# HIDEOUT, UTAH PLANNING COMMISSION SPECIAL MEETING AND PUBLIC HEARING

## Staff Review of Plan Submittal

Re: Deer Springs – Final Subdivision Approval for Phases 2A and 2B

## **Staff Report for the Boulders – Development Agreement Review and Rezone Request**

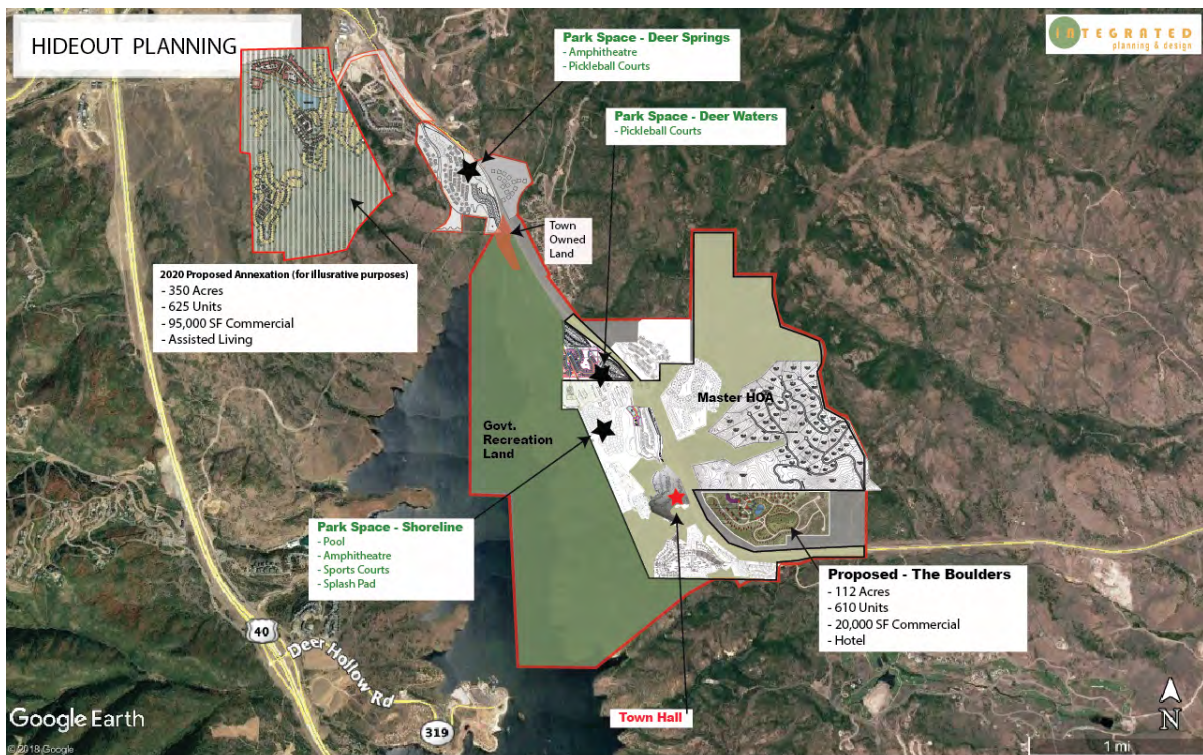
- ii. The Planning Commission should review the map prepared and included at the beginning of this Staff Report to confirm the type of amenities needed in Town. Some are duplicative: Deer Springs includes an amphitheater and park as part of Phase 3. Deer Waters includes pickleball courts. Subsequent phasing in Shoreline also includes a pool, an amphitheater, sports courts, splash pad, etc.

## OPEN SPACE

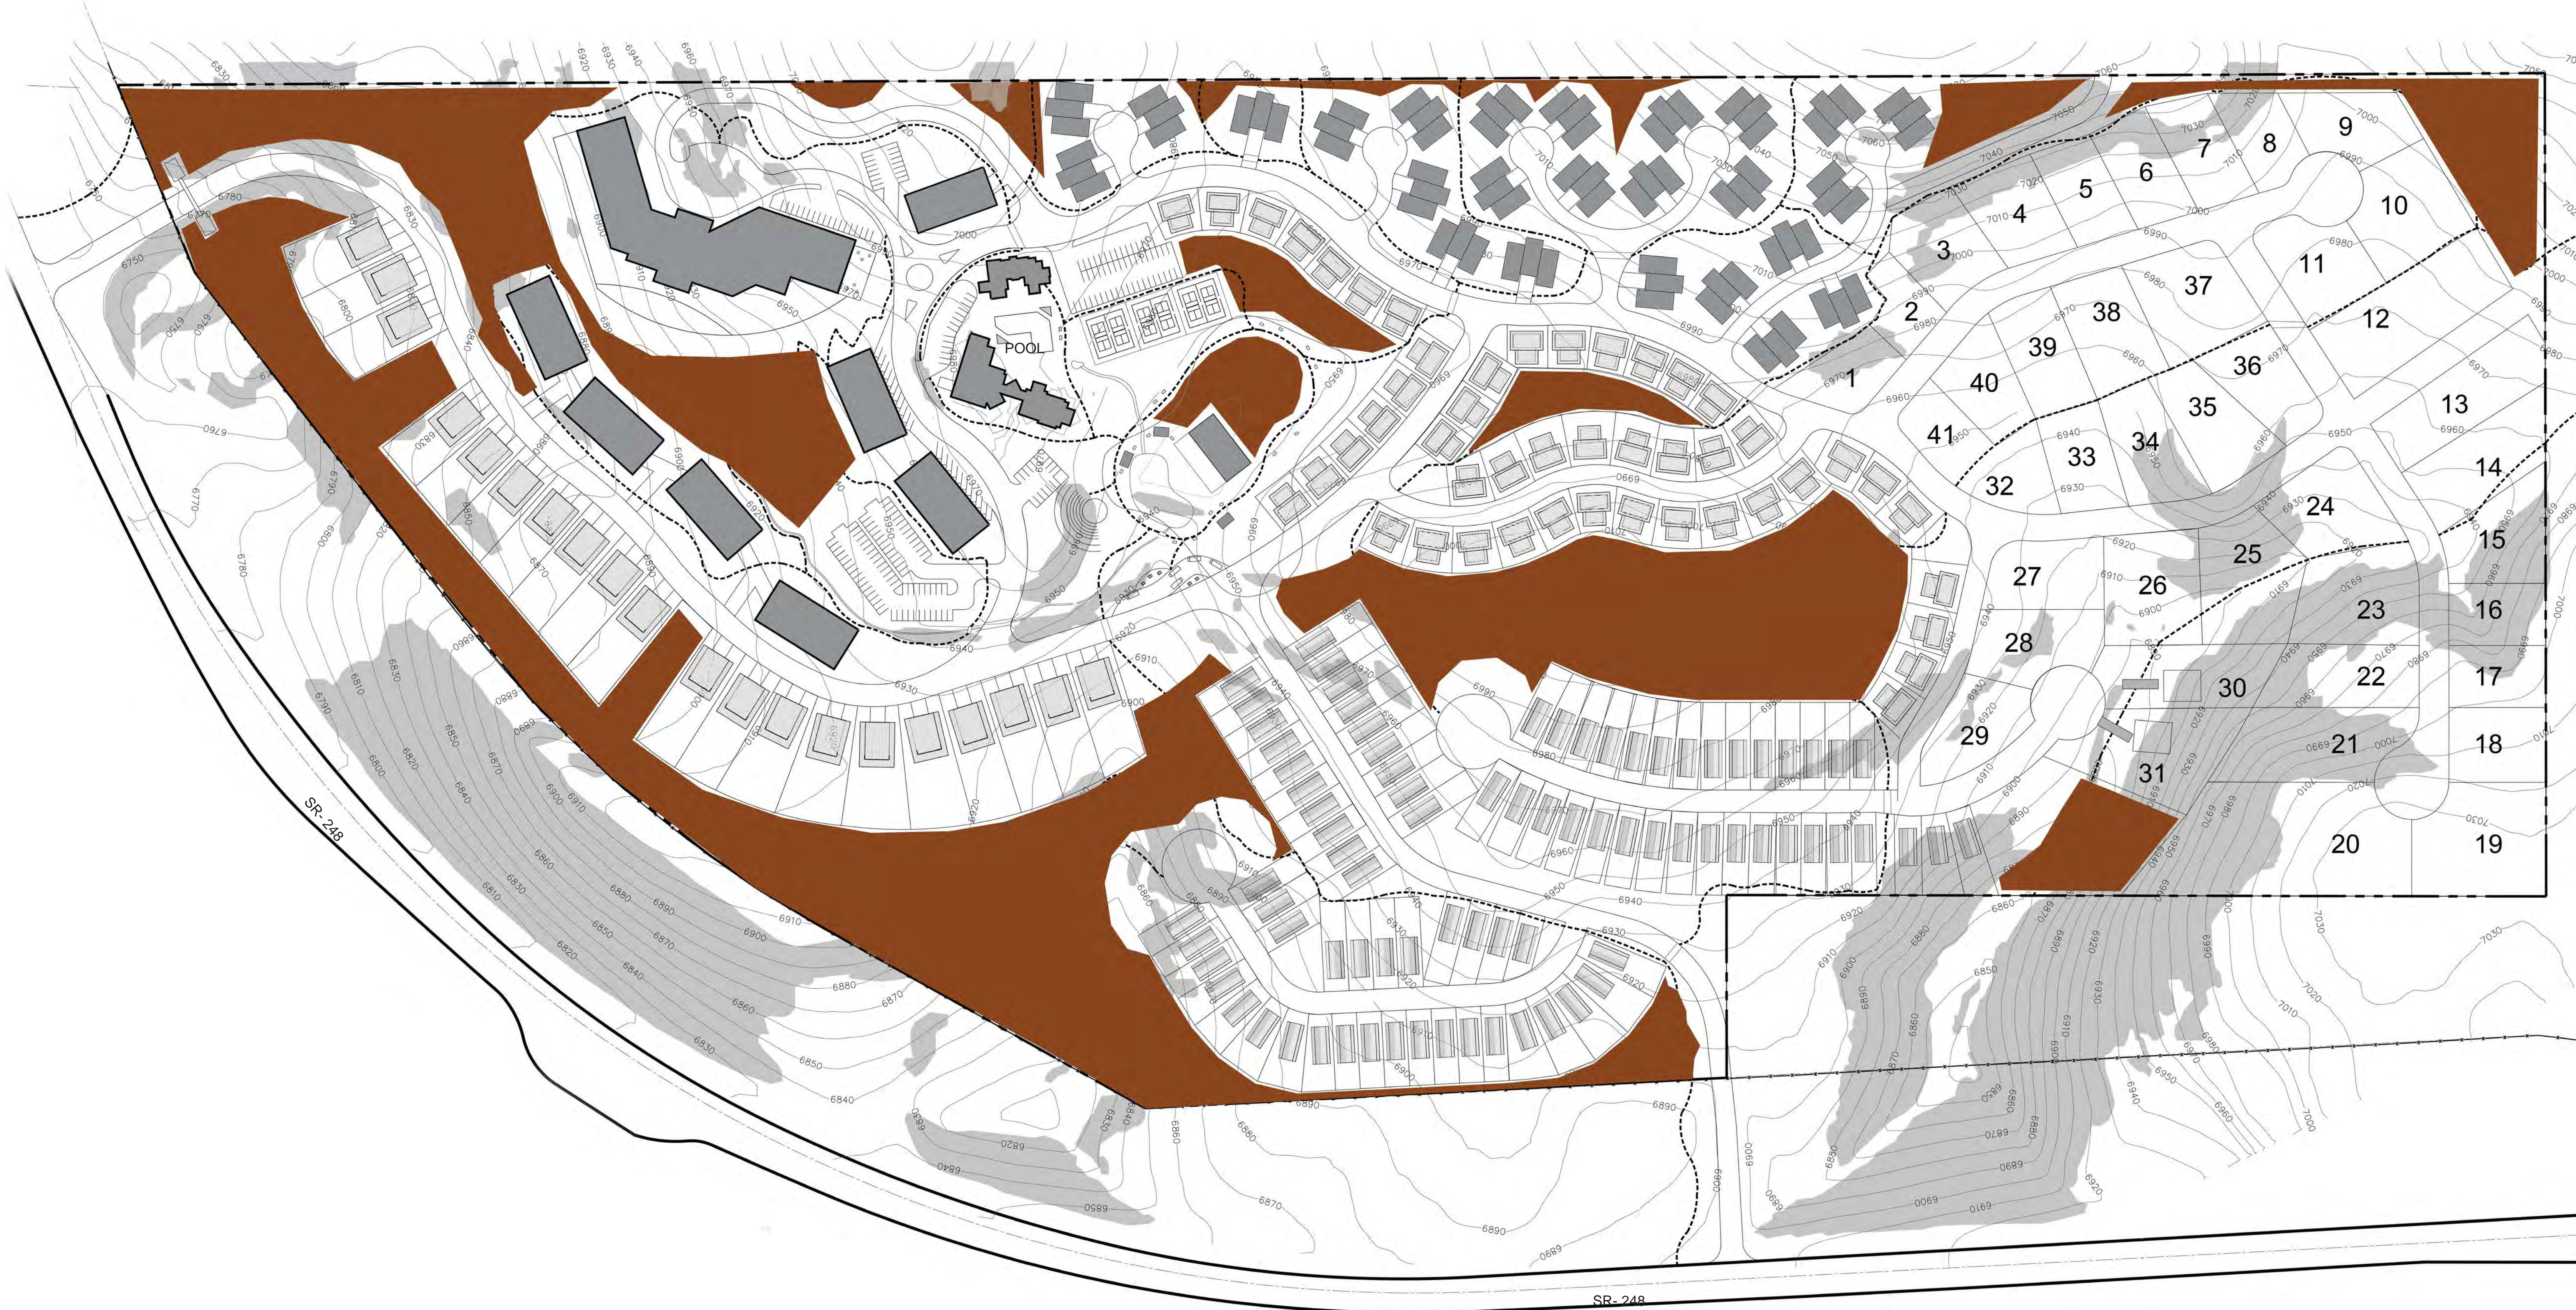
- a. A minimum of 45% of the total (gross) site was proposed as undisturbed to the Planning Commission.
- b. Updates to the preliminary grading plan have seen this reduced to 5% – 15% of the site as undisturbed.

- a. The Planning Commission must provide input regarding the maximum amount of land disturbance permitted. Recent projects, Shoreline Phase 3 and Lakeview, with the densities proposed, required an almost complete denuding of the sites to accommodate development.

- c. This value must be defined numerically in the MDA
- d. 'Undisturbed land' must be defined in the MDA
- e. Areas to remain undisturbed must be illustrated on a site plan and included in the MDA.
